Ordinary Meeting

| CL23.76 | DA22/1542 – 1 Buchan St Mollymook – Lot 14 DP 20321 | |
| Attachment 6 | Planning Report S4.15 Assessment - 1 Buchan St - Mollymook - Lot 14 DP 20321 | 70 |

Section 4.15 Assessment Report - DA22/1542 – 1 Buchan St Mollymook

Figure 18: Proposed East Elevation

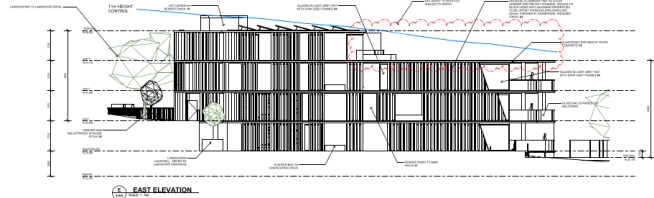
building is compliant with the relevant controls. The 11-metre height line is shown in blue in Figure 18.

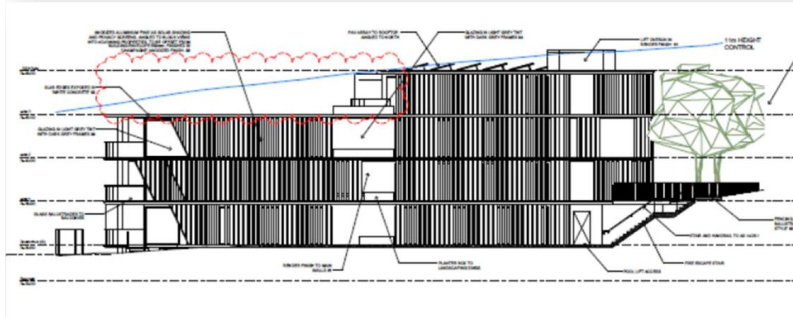
These issues have been addressed as follows:

- **Height Limit:** The building has been redesigned to step down the site which has been achieved by reducing the footprint of the upper floor apartments which are now 2 bedrooms. The northern end of the building is now well within the height limit.

- **Rear Setback:** The revised plans show the building setback 9m to comply with SEPP 65.
- **Minimising Amenity to Seaview St:** The above changes to building height, rear setback and stepping down of the building will minimise the impact top the Seaview St properties.
- **Precedent:** The building is now compliant with SEPP 65, The Apartment Design Guide and the provisions of Shoalhaven DCP Chapter V3 in relation to minimising the impacts on Seaview St.

Figure 3F.5 To resolve amenity impacts, apartment buildings should increase the building separation distance (+3m) when adjacent to a different zone that permits lower density residential development

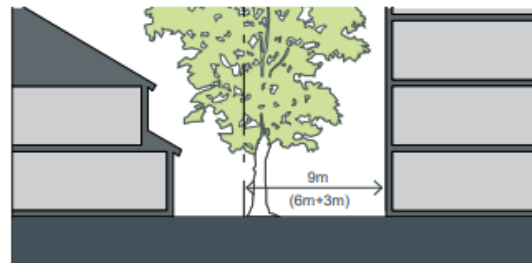
This provides adequate transition as provided at 3F-1.

Figure 3: Street elevation, showing the building within the 11 metre height limit (blue line)

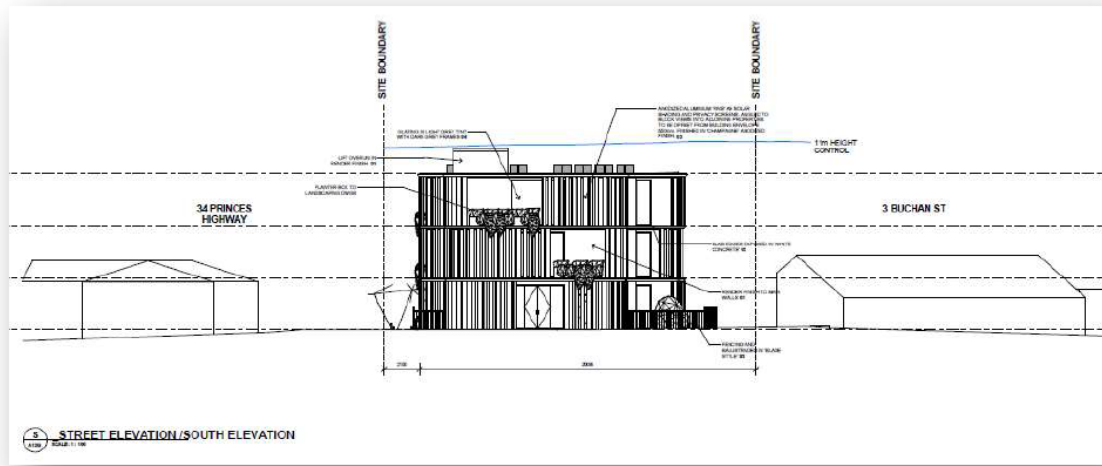
Figure 2: The building is within the 11-metre height limit when viewed from the street, as shown on the extract from the street elevation plan at Figure 3 below.

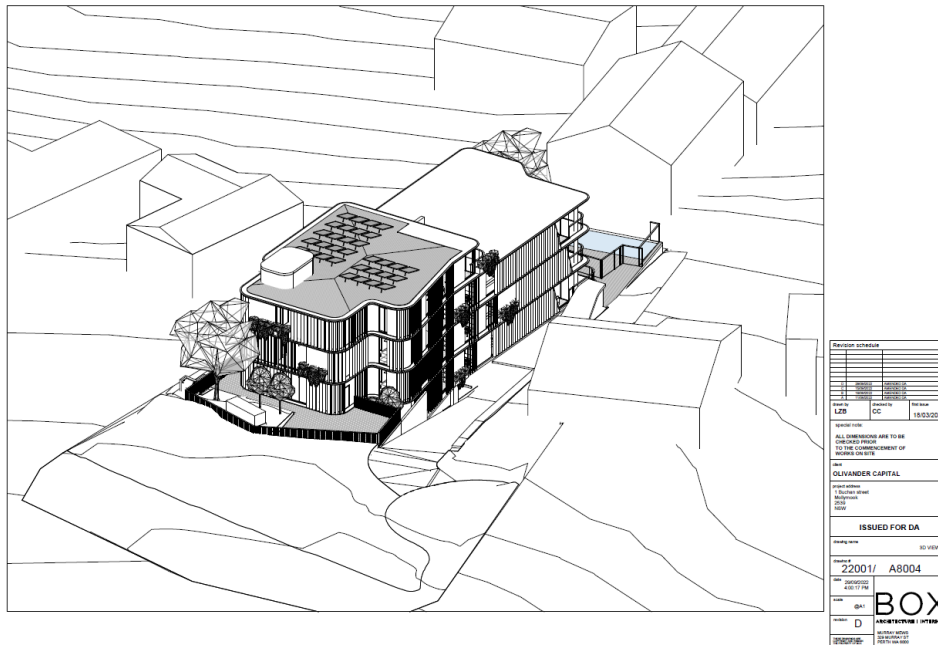
The 0.3m or 2.7% exceedance is considered to be minor and considering the small size of the structure will not have any adverse impacts on the streetscape character, privacy, views and solar amenity to surrounding residents. The solar collector exceedance of 0.1m is a very small exceedance of

0.9% and it is noted that solar collectors can be installed as exempt development under *State Environment Planning Policy (Transport and Infrastructure) 2021*.

Given the circumstances outlined above, the proposed height exceedance is considered reasonable having regard to the building design, its purpose and site characteristics.
